The Ashville

BUILDER	Ben Stout Real Estate	COUNTY	Harnett
JOB NAME	Lot 31 Forest Ridge	ADDRESS	Tanna Place
PLAN	The Ashville	MODEL	Floor
SEAL DATE	N/A	DATE REV.	01/07/21
QUOTE #	Quote #	DRAWN BY	David Landry
JOB #	J1220-5670	SALESMAN	Marshall Naylor

Subject: The Ashville House Plan
Harnett County

1 Truss Placement Plan
Scale: 1/4"=1'

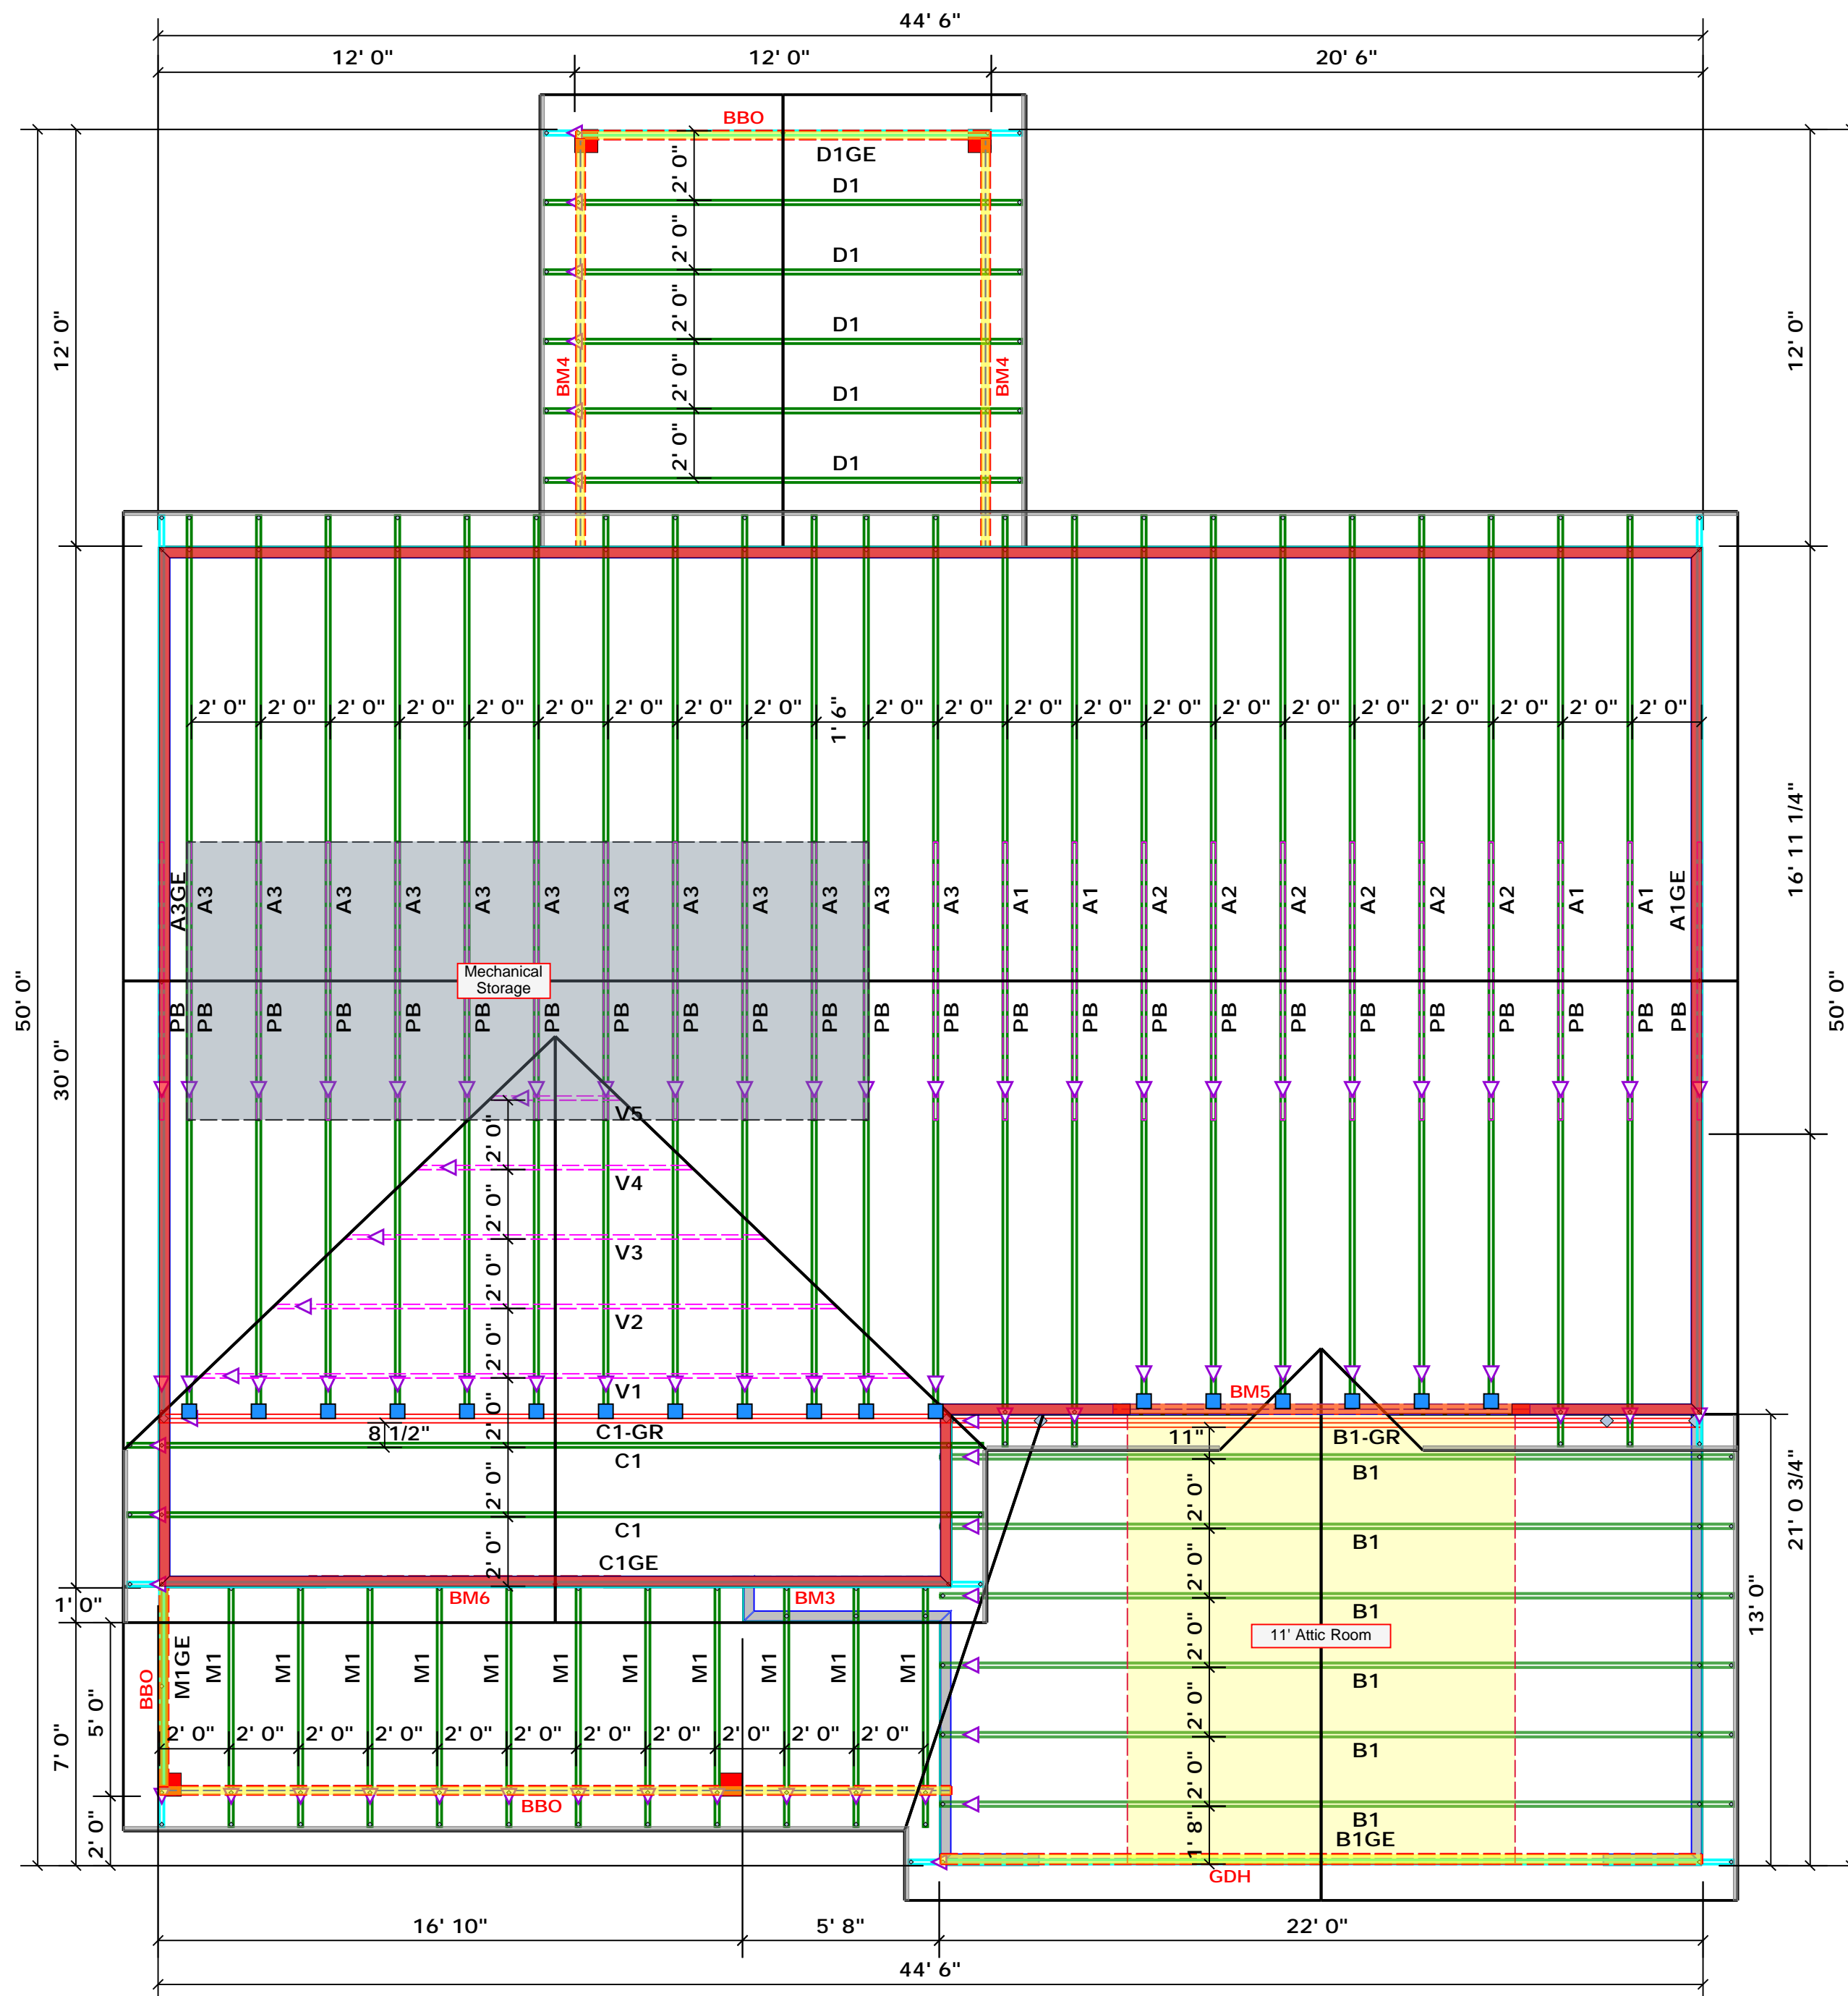
At the junction where trusses C1GR and B1GR meet, there is a significant load being transferred to the footing below. However, the 36" x 36" x 8" footing will support the load.

Truss C1GR is a two-ply, and truss B1GR is a three-ply truss. Fasten the truss members together according to the note on the truss design sheets.

Both trusses require larger support columns. Follow the dimensions on the truss drawings and install the correct number of studs. Fasten the studs together with two rows of 10d nails in each stud.

The design depicted in the drawings and trusses cut-sheets is structurally adequate. I have no structural concerns regarding this house.
